## STAFF REPORT AND RECOMMENDATION TO THE DESIGN COMMISSION

CASE FILE: LU 16-278621 DZM GW  
 PC # 16-262122  
**Fremont Apartments**  
 REVIEW BY: Design Commission  
 WHEN: September 28, 2017 @ 1:30pm  
 WHERE: 1900 SW Fourth Ave., Room 2500A  
 Portland, OR 97201

BUILDING ELEVATIONS - NORTH C.13

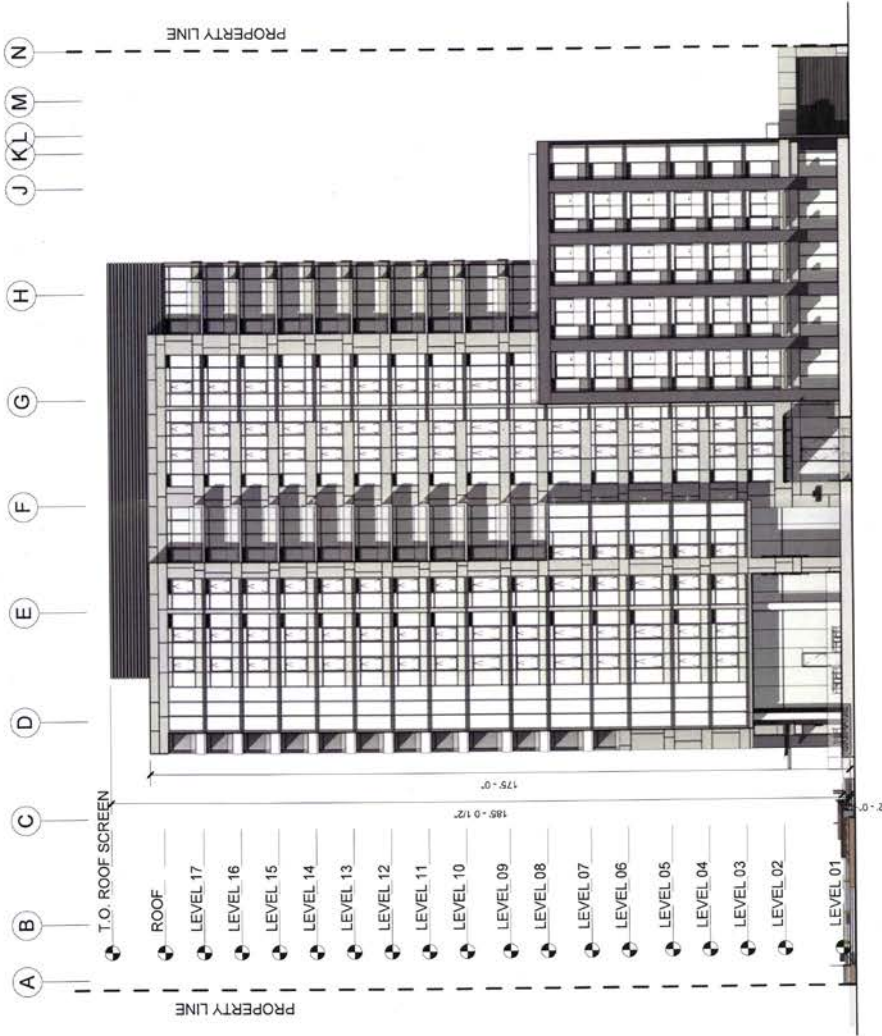
- The tower mass expresses its verticality on the north elevation with a regular series of flat piers that divide the façade into vertical window bays. These bays are further defined by aligned windows and Juliette balconies. This expression is lost somewhat on the other elevations, which lack the regular vertical pier expression to accommodate wider window bays. This more-horizontal expression is further reinforced with horizontal spandrels of varying widths. To retain some of the verticality expressed on the north façade and in the podium masses, the south courtyard elevation may provide a good example to follow, where the window bays have a wider expression, yet narrow vertical columns still help to divide the façade into vertical proportions.

- Another massing element protrudes out of the north elevation above the five-story podium. A one-story space is left between this mass and the podium below. From the east, this reads almost as a cantilever, which is an awkward expression on this building. It also brings this mass into the same plane as the podium below, which complicates the expression of the three primary masses. This should be pulled back into the primary tower massing.
